LEXINGTON-FAYETTE URBAN COUNTY GOVERNMENT CONTRACT CHANGE ORDER Page 1 of 2	Date:	November 10, 2016
	Project:	Public Safety Operations Center Phase 1B Renovation
	Location:	115 Cisco Road
To (Contractor): Churchill McGee, LLC 1315-C West Main Street Lexington, KY 40508	Contract No.	287-2014
	Original Contract Amt.	\$6,109,000.00
	Cumulative Amount of Previous Change Orders	\$556,322.45
	Percent Change - Previous Change Orders	9.11%
	Total Contract Amount Prior to this Change Order	\$6,665,322.45
	Change Order No.	16

CHANGE ORDER: 16

Subject: Electrical Room 142 Ductless Split Cooling Unit

SUBJECT: RFP 13 – Electrical Room 142 Ductless Split Cooling Unit

PARTIAL FLOOR PLAN - AREA A

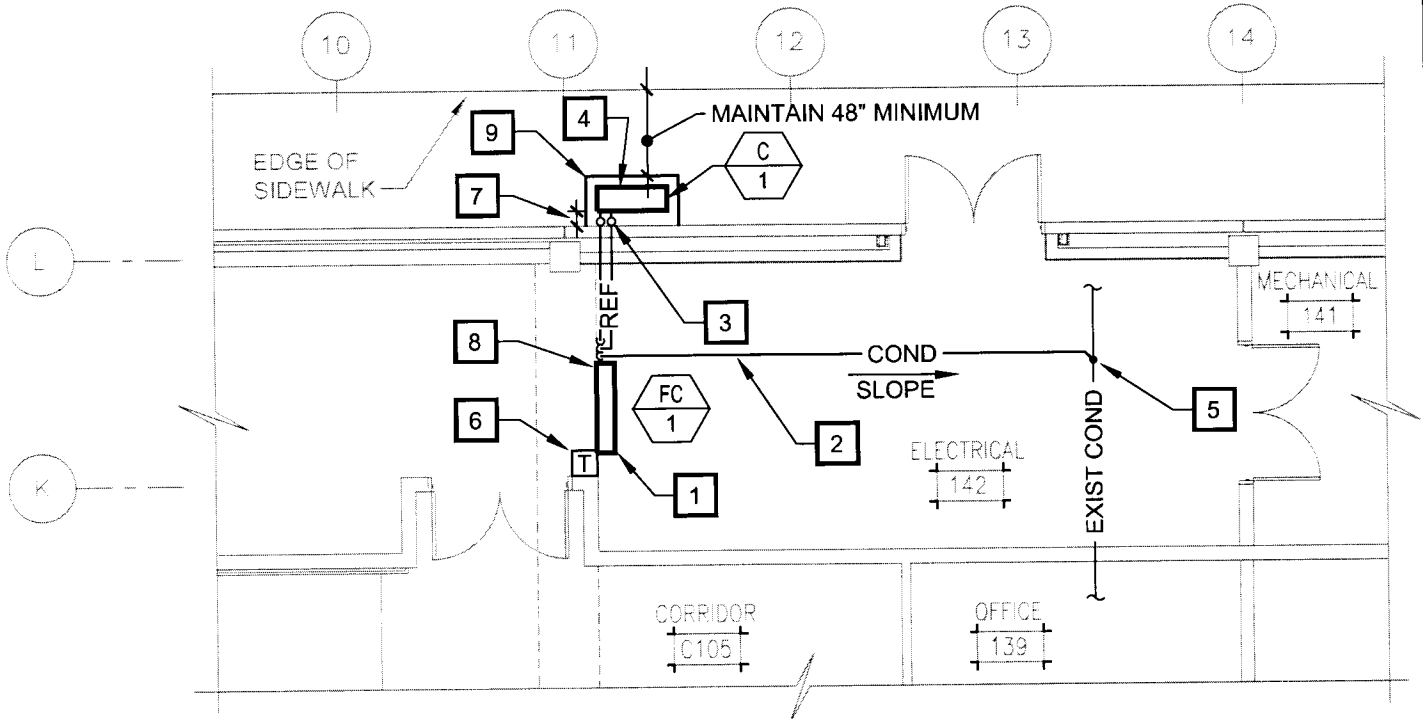
Since commissioning, Electrical Room 142 was found to be consistently warm (in the upper 70s) when outdoor air temperatures are above approximately 80 deg F. Marcum Engineering has reviewed records and the as-built conditions. The contribution to the high heat load is due to be the large UPS system which rejects 36,000 BTUH in lieu of the 18,000 BTUH allowed. The UPS system supports both Phase 1B and Phase 2 (911) electrical loads. The large cooling load required for the UPS will present additional problems in the winter as that VRV systems cannot support a heat recovery system that is predominately in heating mode with one zone requiring cooling. Therefore, the addition of VRV Fan Coils will not satisfy the cooling dominate load during the winter.

The solution is the addition of a 3 Ton cooling only unit. This unit will provide the cooling needed for the UPS during the winter and the additional cooling needed during the summer. A 3 Ton ductless split system can handle the localized heat gain from the UPS. Meanwhile, the heating and cooling of the space will continue to be supplied by the two (2) existing VRV units. This solution will maintain a room temperature of approximately 72 degrees F (as approved by LFUCG).

Reference Drawings H1.1 and E1.3 and the attached Sketches XME01 and XME02. The Contractor shall provide a proposal for the following:

#	
1	MOUNT INDOOR UNIT AND REFRIGERANT PIPING ON SIDE OF EXISTING CONCRETE ROOF BEAM.
2	ROUTE CONDENSATE PIPING HIGH AS PRACTICAL. COORDINATE WITH EXISTING CONDITIONS.
3	ROUTE REFRIGERANT PIPING UP AND PENETRATE WALL AT BEAM ELEVATIONS. COORDINATE WITH EXISTING ELECTRICAL PANELS AND COMPONENTS.
4	SECURE OUTDOOR UNIT TO STAND AND SECURE STAND TO CONCRETE SIDEWALK WITH ANCHOR BOLTS.
5	CONNECT NEW 1" CONDENSATE PIPING TO EXISTING CONDENSATE PIPING. SLOPE DOWN FROM UNIT TO EXISTING. FIELD VERIFY EXISTING LOCATION.
6	INSTALL THERMOSTAT ABOVE EXISTING AND LABEL EACH RESPECTIVELY AS: "VRVD-142A/142B = HEATING & COOLING" AND "FC-1 = COOLING ONLY". THE CONTRACTOR SHALL CHANGE THE VRV SET-POINTS TO 74°F COOLING AND 65°F HEATING WITHIN THE DDC PROGRAMMING. THE CONTRACTOR SHALL SET THE COOLING ONLY THERMOSTAT FOR FC-1 TO 72°F OF YEAR AROUND OPERATION.
7	DO NOT EXCEED 8" UNLESS MANUFACTURER REQUIRES MORE CLEARANCE.

8	ELECTRICAL CONTRACTOR SHALL FURNISH AND INSTALL A NEW 2P20A BRANCH BREAKER IN THE AVAILABLE SPACE OF PANEL EA2 AND EXTEND 2-#12'S, #12 GRD. IN 1/2" CONDUIT TO C-1, FURNISH AND INSTALL A 2P30A NON-FUSED NEMA 3R DISCONNECT AND MAKE FINAL CONNECTION TO C-1 IN LIQUID TIGHT FLEXIBLE METAL CONDUIT. COORDINATE WITH MECHANICAL CONTRACTOR AND FURNISH AND INSTALL POWER CONNECTION BETWEEN OUTDOOR UNIT AND INDOOR UNIT.
9	EQUIPMENT STAND. SEE HVAC SCHEDULE.
